VA.R. Doc. No. R16-4665; Filed April 9, 2018, 1:25 p.m.

Final Regulation

Title of Regulation: **13VAC5-63, Virginia Uniform Statewide Building Code (amending 13VAC5-63-10, 13VAC5-63-20, 13VAC5-63-30, 13VAC5-63-40, 13VAC5-63-50, 13VAC5-63-70, 13VAC5-63-80, 13VAC5-63-130, 13VAC5-63-150, 13VAC5-63-170, 13VAC5-63-190, 13VAC5-63-200, 13VAC5-63-210, 13VAC5-63-220, 13VAC5-63-230, 13VAC5-63-235, 13VAC5-63-240, 13VAC5-63-245, 13VAC5-63-250, 13VAC5-63-260, 13VAC5-63-264, 13VAC5-63-270, 13VAC5-63-280, 13VAC5-63-290, 13VAC5-63-295, 13VAC5-63-298, 13VAC5-63-300, 13VAC5-63-310, 13VAC5-63-320, 13VAC5-63-330, 13VAC5-63-336, 13VAC5-63-360, 13VAC5-63-370, 13VAC5-63-400, 13VAC5-63-410, 13VAC5-63-420, 13VAC5-63-430, 13VAC5-63-434, 13VAC5-63-438, 13VAC5-63-440, 13VAC5-63-443, 13VAC5-63-450, 13VAC5-63-470, 13VAC5-63-480, 13VAC5-63-490, 13VAC5-63-500, 13VAC5-63-510, 13VAC5-63-520, 13VAC5-63-530, 13VAC5-63-540; adding 13VAC5-63-268, 13VAC5-63-431, 13VAC5-63-432.5, 13VAC5-63-433, 13VAC5-63-433.3, 13VAC5-63-433.5, 13VAC5-63-434.5, 13VAC5-63-435, 13VAC5-63-435.5, 13VAC5-63-439, 13VAC5-63-441, 13VAC5-63-485, 13VAC5-63-524, 13VAC5-63-545, 13VAC5-63-549; repealing 13VAC5-63-225, 13VAC5-63-350).**

FIGURE R602.3(2)
FRAMING DETAILS

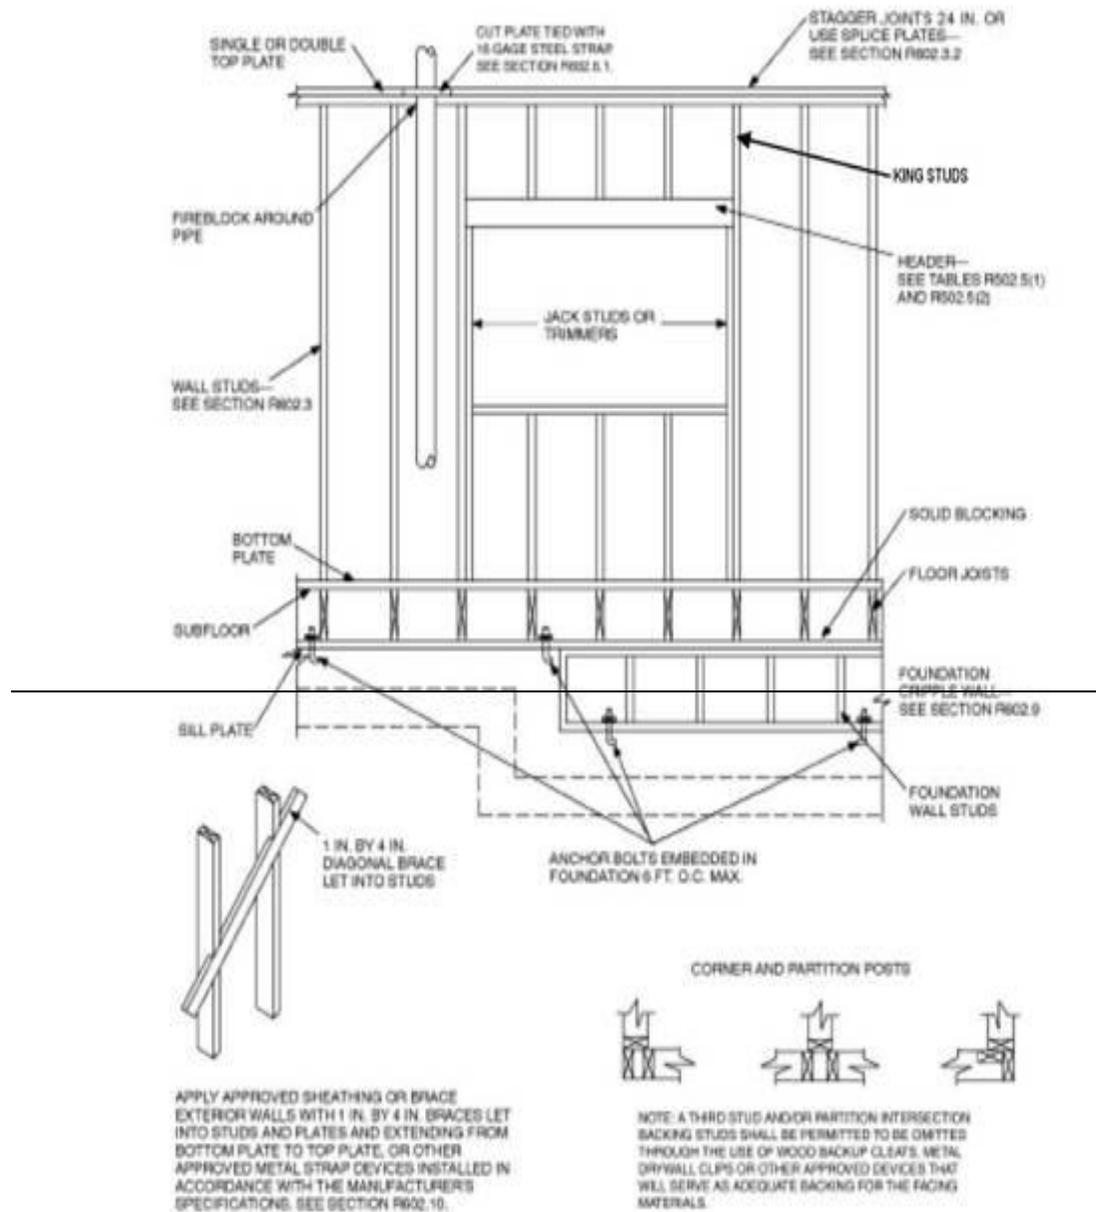
55. Change Figure R602.3(2) to read:
